DEPARTMENT OF TRANSPORTATION**National Highway Traffic Safety Administration****49 CFR Part 571**

Federal Motor Vehicle Safety Standards; Bus Emergency Exits and Window Retention and Release

ACTION: Final rule.

Figure 3D

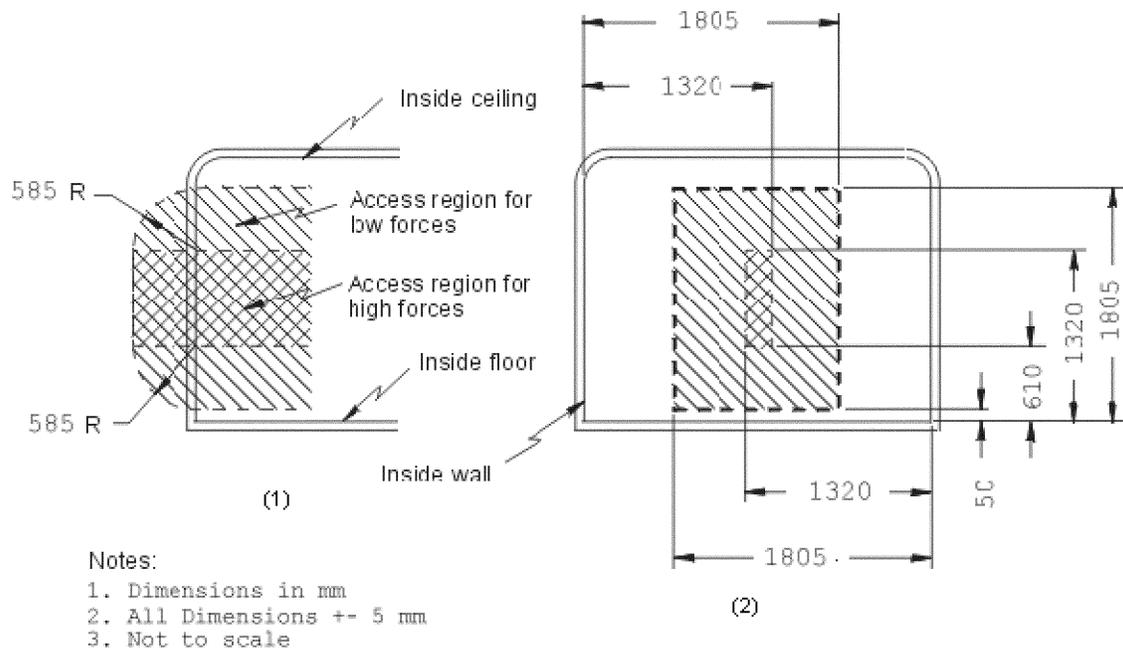
The standard currently specifies at S5.3.3.1(a) and Figure 3D of the standard that both the interior and exterior releases (handles) for rear emergency exit doors be located in the center of the door.³ However, school bus manufacturers have always understood the standard as requiring only interior releases (interior handles) to be in the center of the door. They believed that the exterior handle may be near the edge of the door on the side opposite the hinges. They further believed that an exterior release (exterior handle) so located provides more leverage and may be designed to require less force to open the rear emergency exit door as compared to an exterior handle located in the center of the door.⁴

Accordingly, we proposed to amend FMVSS No. 217 to specify that the exterior release (exterior handle) for the exit must only be in the high force access region shown in the left-side drawing (side view) of current Figure 3D; that is, only the vertical dimensions of the high force region are specified for the location of the exterior handle. We sought comment on whether we should require the exterior release to be no further than 51 millimeters (mm) (two inches) away from the edge of the door opposite the hinges.

We also clarified the requirement that the interior release (interior handle) for a rear emergency exit must be in the high force access region shown in both drawings of current Figure 3D, i.e., in the center of the door.

In addition, to make Figure 3D easier to understand, we proposed to rename the left-side drawing "Figure 3D(1)" and the right-side drawing "Figure 3D(2)."

In its comment, Blue Bird stated that Figure 3D already has the required two drawings and only needs to change the width of the "ACCESS REGION FOR HIGH FORCES" in the right-hand drawing to span the entire door. Blue Bird stated that the proposal to split Figure 3D into Figures 3D(1) and 3D(2) did not seem necessary and may recreate the problem of using a single

We do not agree with Blue Bird's suggestion that the high access region depicted in Figure 3D(2) (right side drawing) extends across the entire width of the door. The access region depicted in Figure 3D(2) (front view of the access regions for the rear emergency exit without rear obstruction) provides the location requirement for the interior release mechanism (interior handle) and ensures that it is in a location accessible from inside of the school bus. As we explained in the NPRM, the interior release handle for the emergency exit was intentionally required to be located in the center of the door so that it is visible to bus occupants and the view of the handle is not obstructed by seat backs. Further, as noted by SBMTC, the exit would be opened from inside by a pushing motion rather than a pulling motion, so locating the handle in the center of the door does not markedly increase the difficulty of opening the door.

Further, we do not agree with Blue Bird's suggestion not to split Figure 3D into Figures 3D(1) and 3D(2). Splitting Figure 3D into two parts allows referencing the two figures individually, to provide separate location requirements for the interior and exterior release mechanisms. As explained earlier, we intentionally described the interior handle as being in the center of the door, as indicated by Figures 3D(1) (side view) and 3D(2) (front view). However, for exterior release handles, which are not at risk of being obscured, we are only specifying the vertical dimensions of the high force region and are providing flexibility to the manufacturer to place the exterior release handle anywhere along the width of the door, as indicated by Figure 3D(1) alone (with vertical dimensions shown in the front view—3D(2)).

We are adopting the proposed amendment, except for the requirement that the exterior release handle must be no further than 51 mm (two inches) away from the edge of the door. The purpose of the limitation would have been to ensure the emergency exit door opened within the force requirements set forth in the standard. After reviewing the comments, we agree with SBMTC that the force requirements specified in the standard for opening emergency exits are sufficient to meet this goal. It is the opening force, not the closeness to the edge of the door, that is important for opening the door from the outside.

Figure 3D(1) and Figure 3D(2) for an interior release mechanism for a rear emergency exit door, and within the high force access region shown in Figure 3D(1) for an exterior release mechanism for a rear emergency exit door.
